NABCO ENTRANCES TECHNICAL BULLETIN

Sensor Monitoring Problem with BEA IXIO DT1 and Optex OS-12C T Beam controller

Bulletin Number: **78**

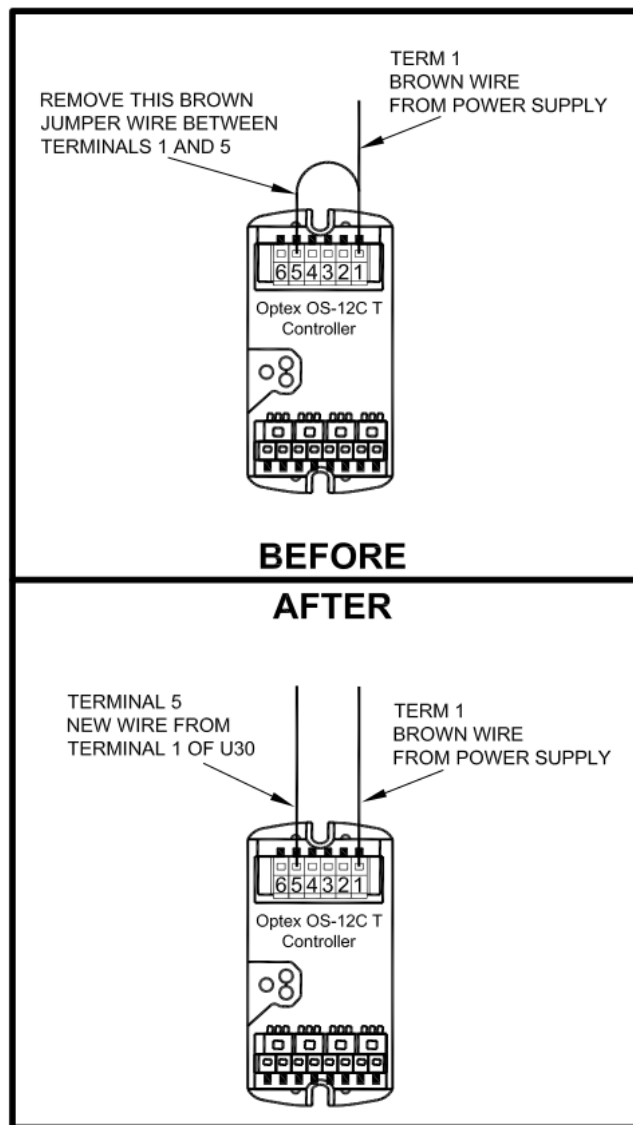
Once the system is powered up, the Optex holding beam controller stops working (red and green LED's are off) and the door holds open.

When the BEA IXIO DT1 sensor is used with the Optex controller and the monitoring voltage levels to each device are different, because of the internal circuitry of the IXIO, the separate voltages are allowed to mix causing the Optex beam controller to stay on.

Remove the brown jumper wire that connects terminals 1 and 5 on the Optex OS-12C T beam controller. Then run a new wire from terminal 5 on the beam controller to terminal 1 on the U30 control. Nothing else needs to be done.
